Re: Ithaca Neighborhood Housing Services and Sundial Property Development, LLC/Claudia Brenner's Proposed Project at 46 South Street in the Village of Trumansburg, New York ("Village") - - **Supplemental Information - Response to Comments from MRB Group and Comments from Village Planning Board**

46 SOUTH STREET TRUMANSBURG, NEW YORK PRELIMINARY SITE PLAN AND SUBDIVISION PLAN

SHEET TITLE
PRELIMINARY PLAT

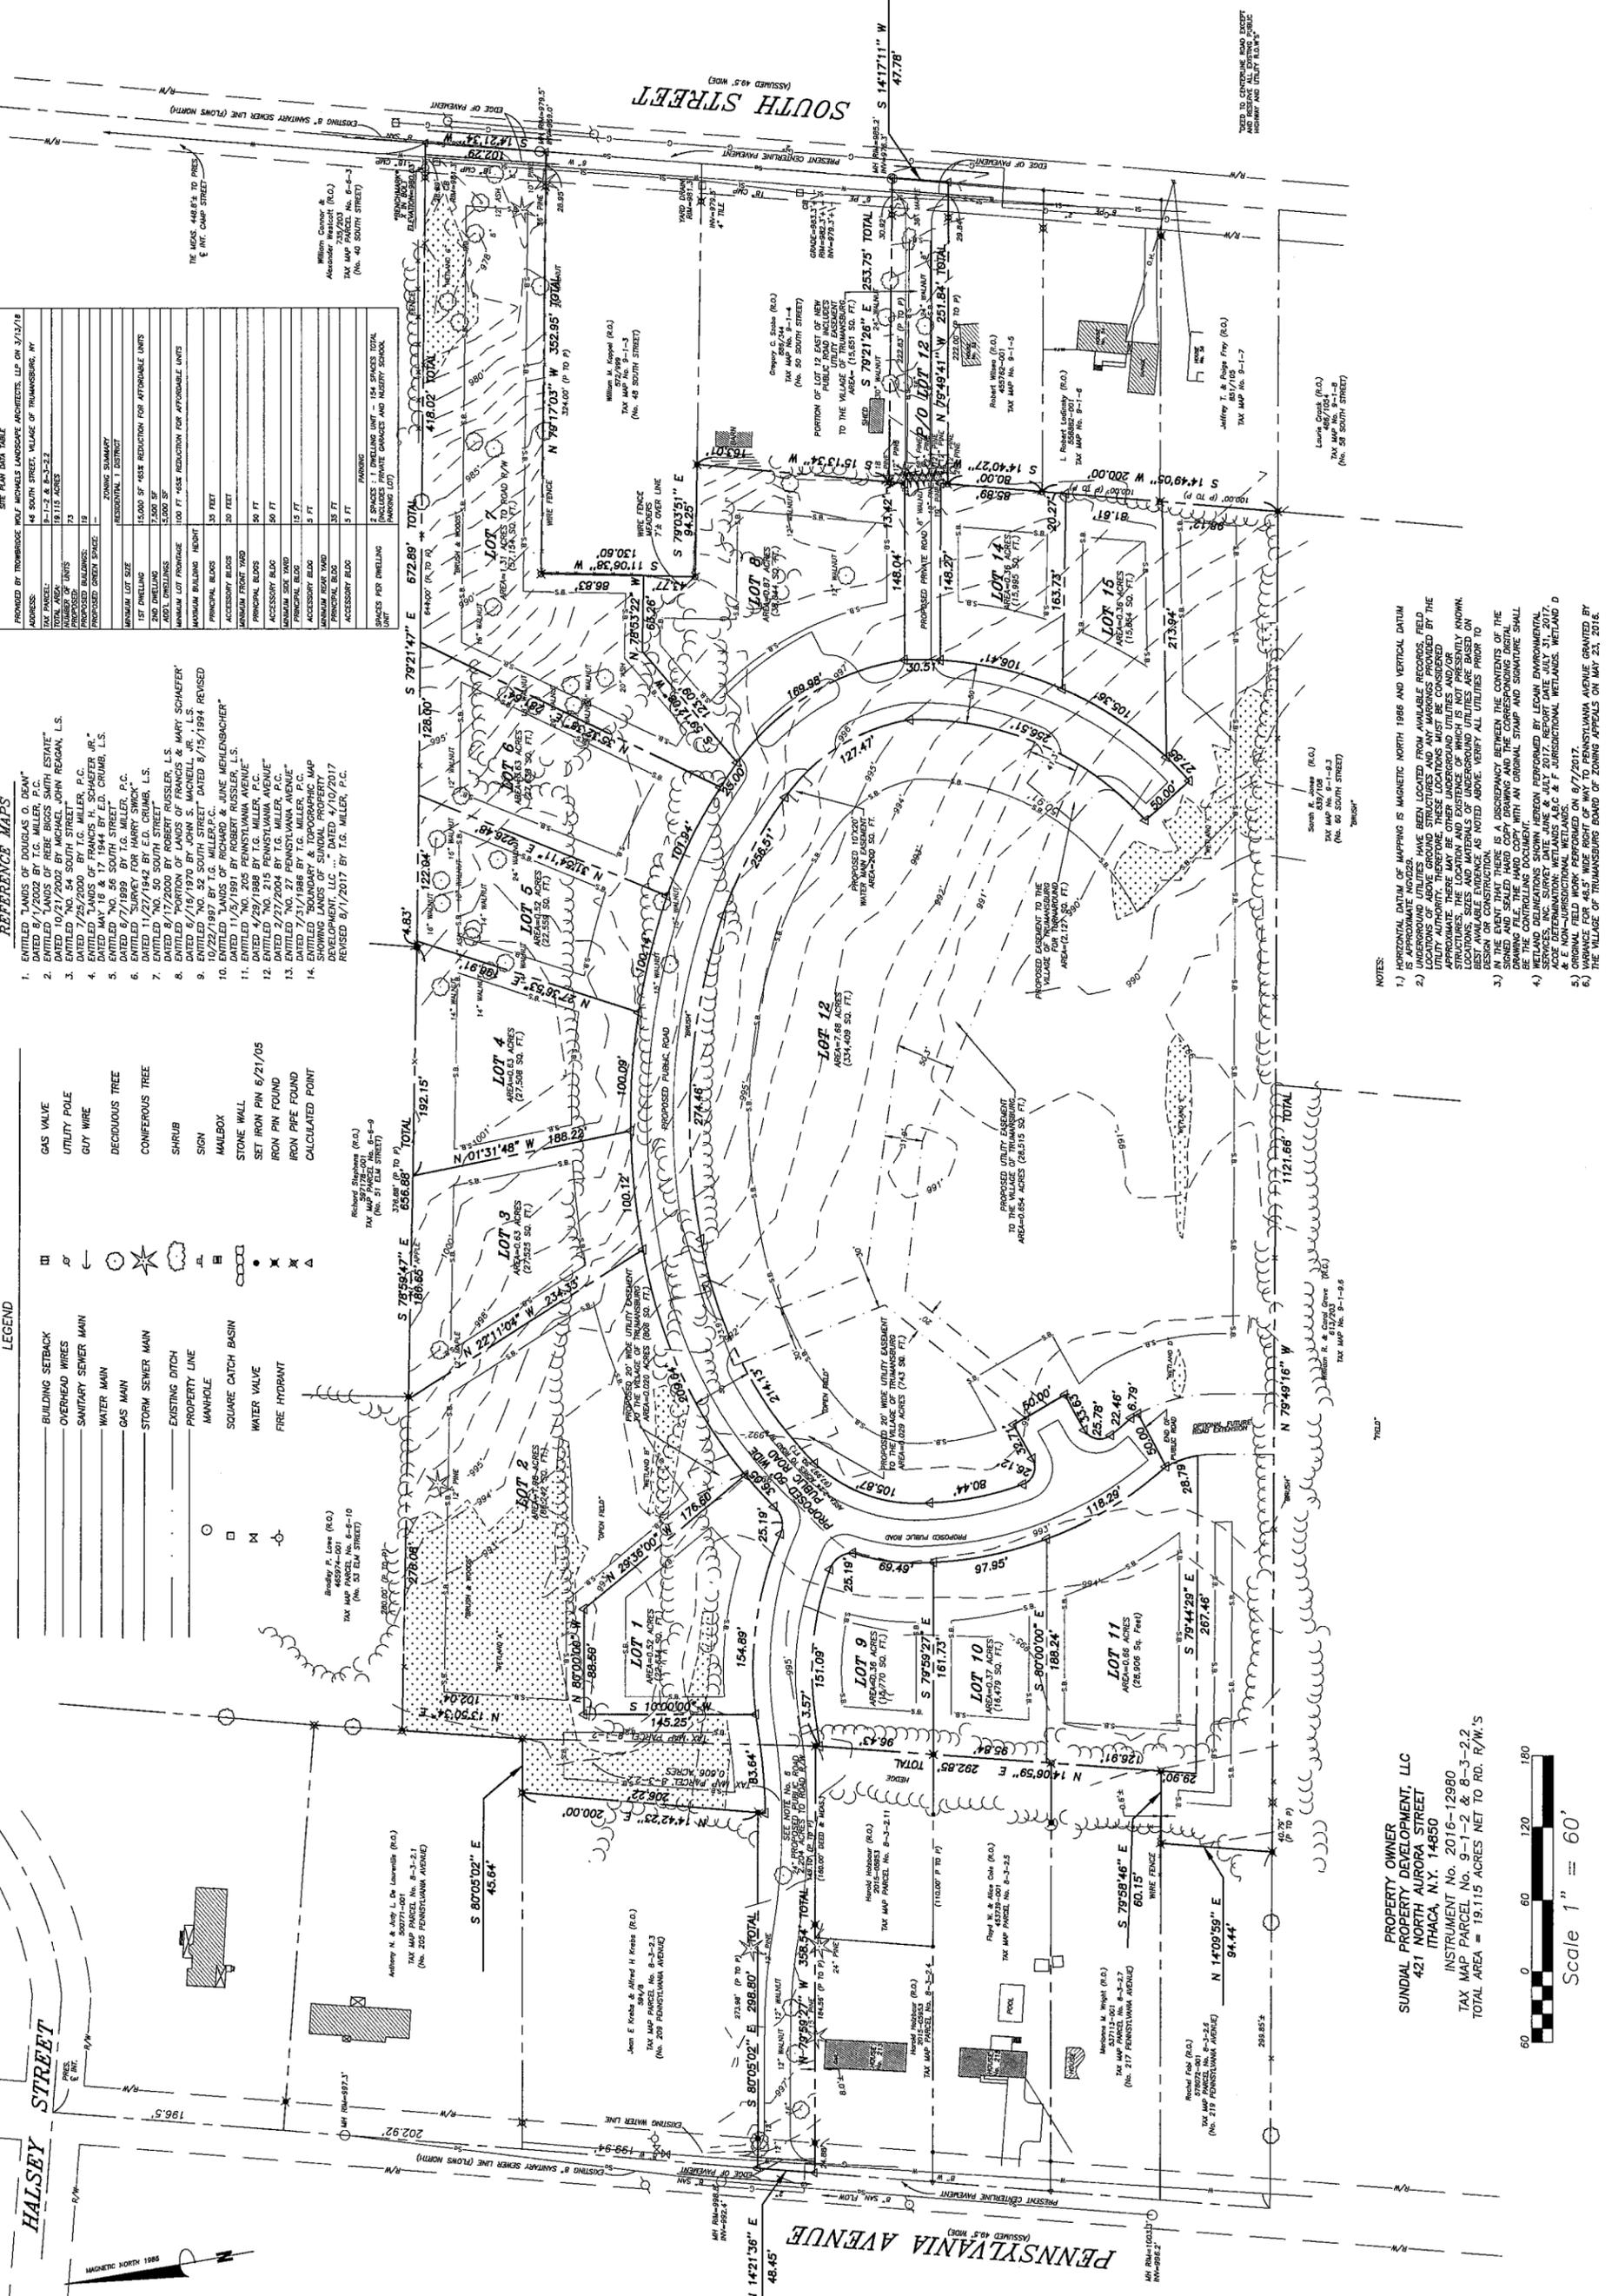
- 5. All variances granted by the ZBA are to be detailed on the site plans.**

24. **All identified wetlands should be shown on the Plat Plan, as they are referenced in the notes. Please provide more information within the notes regarding the wetlands such as the report date, survey date, who surveyed them and the ACOE Determination (if one was provided).**

26. The Site Data Table should be added to the Subdivision Plat.

Applicant's Response: A note detailing the variance for the reduced width of the right-of-way to Pennsylvania Avenue has been added to the Preliminary Plat. See Exhibit B, Site Plan & Preliminary Plat (Note 6).

Applicant's Response: Wetlands and report and ACOE determination information requested has been added to the Preliminary Plat. See Exhibit B, Site Plan & Preliminary Plat. (See Note 6).

Applicant's Response: Site Data Table was added to the Preliminary Plat. See Exhibit B, Site Plan & Preliminary Plat.

UTILITY PLAN

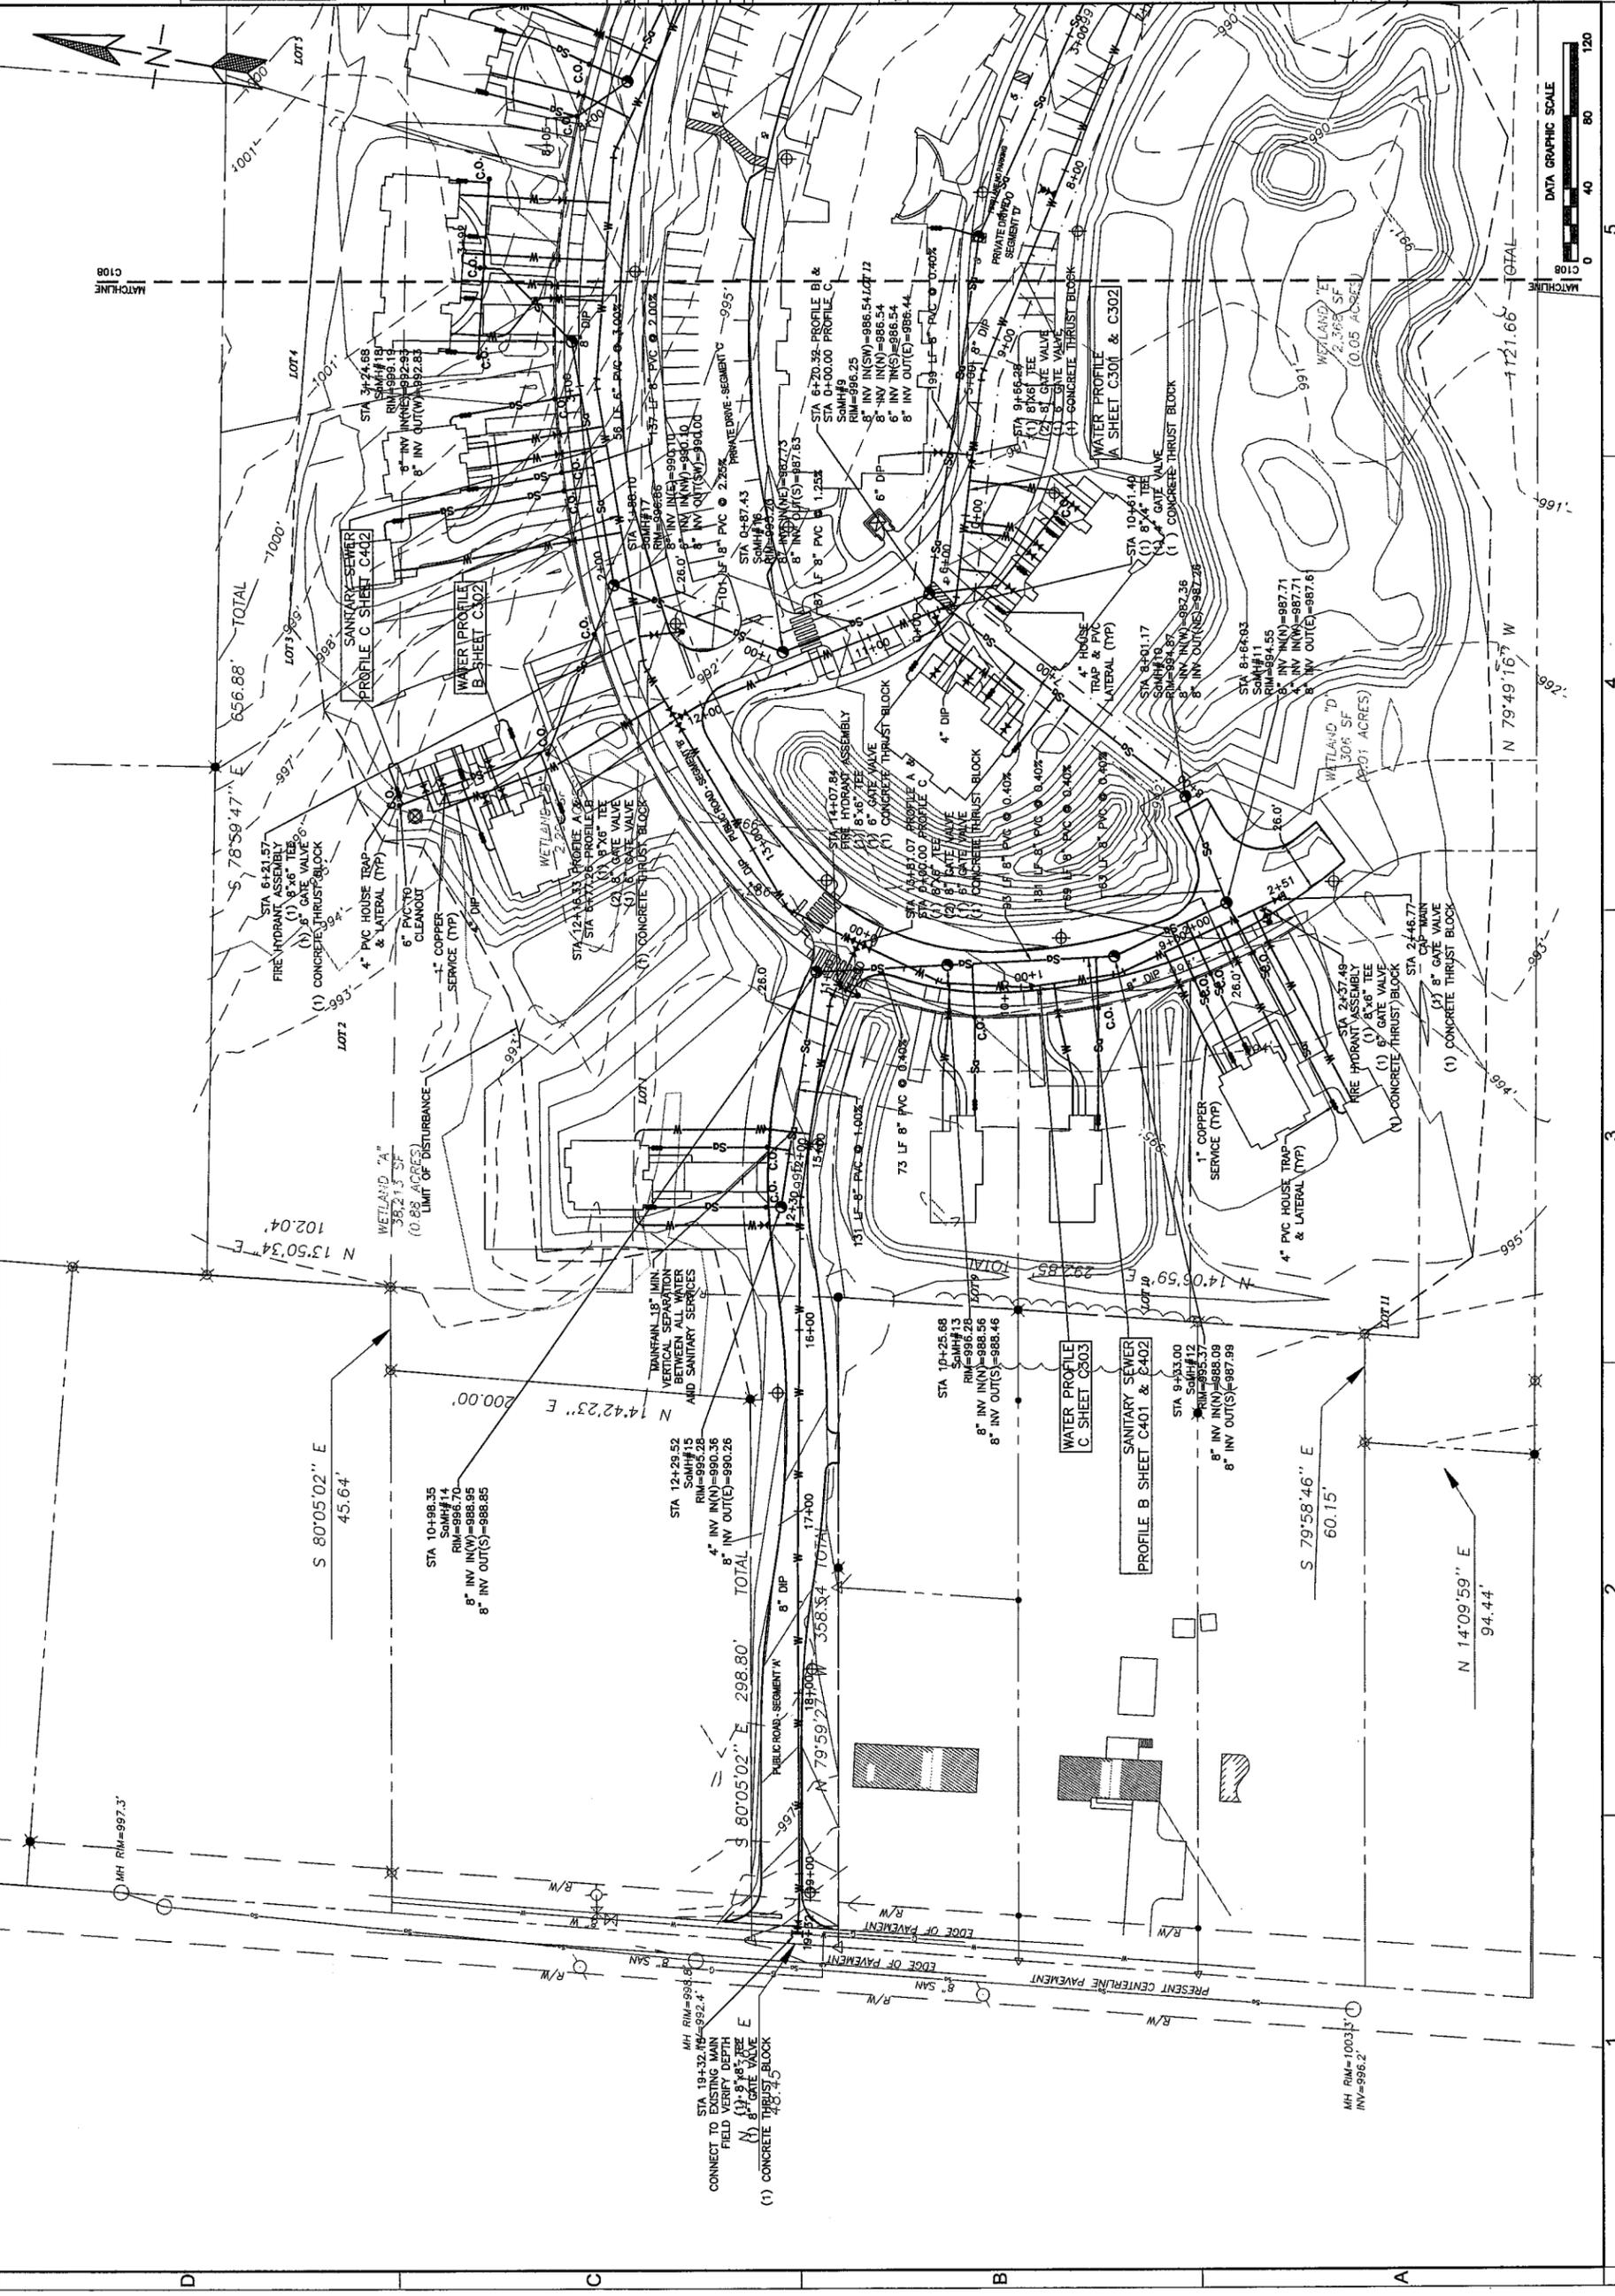
80. On sheet C107, the sanitary sewer lateral extending from Lot #2 is shown crossing the watermain. If possible, the lateral should be connected closer to the manhole to prevent the crossing.

Applicant's Response: The lateral has been connected directly to the manhole. See Exhibit D, Civil Engineering Plans. (Sheets C107).
